Leigh Anne and Phil Francis
Comments on IBR Multi-Use path connections
to the 40-Mile Loop East/West Corridor

IBR Positive Contributions to the 40-Mile Loop Trail

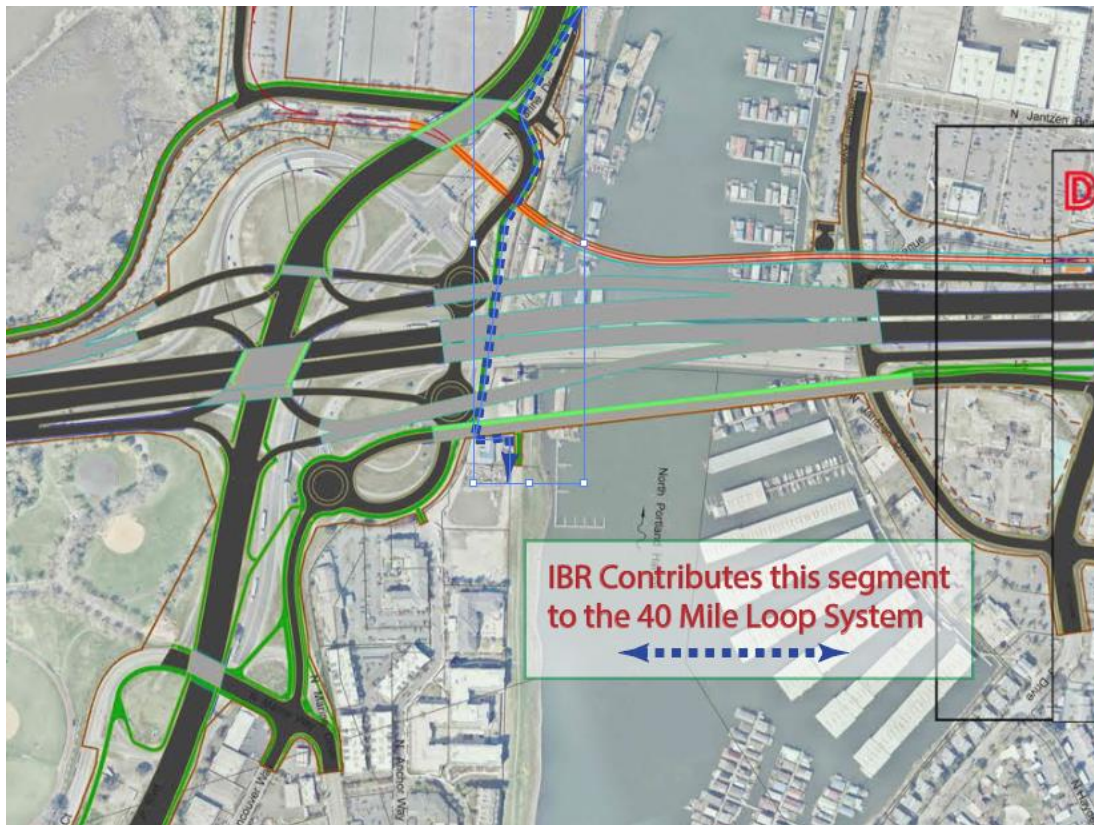
However, the proposed trail connections from the multiuse path on the local Harbor Bridge to the new 40-Mile Loop segment is not optimal. The proposed design requires users to travel out of their way, navigating a traffic circle and crossing vehicle lanes to reach both the eastbound and the westbound trail connection. This routing is neither convenient nor efficient and could discourage its use.

We strongly recommend that alternative design options be considered to provide a more direct, connection to and from the east and west to the local Harbor Bridge multiuse path.

- 1) Creating a direct connection from the East stub of the Bridgeton Trail to the sidewalk on the east side of the local Harbor Bridge. This direct connection would make it easier and more appealing for cyclists and pedestrians to cross the Harbor Bridge, while also offering a scenic route with views of North Portland Harbor and Mt Hood.

- 2) Additionally, we request that the sidewalk on the east side of the local Harbor Bridge be designed to be as wide as possible, with areas to rest and enjoy the views, further enhancing the experience for users.

- 3) Study more direct trail connections from the local Harbor Bridge multi use path to both the east and the west that do not involve routes around the Marine Drive traffic circles and crossing travel lanes.

- 4) Study routing the IBR entire multiuse path on the west side of the bridges rather than the east side. If the multiuse path was located on the light rail bridge on the west side, the east and west connection would be straight forward and direct. The west side multi use path is discussed more in a separate comment.
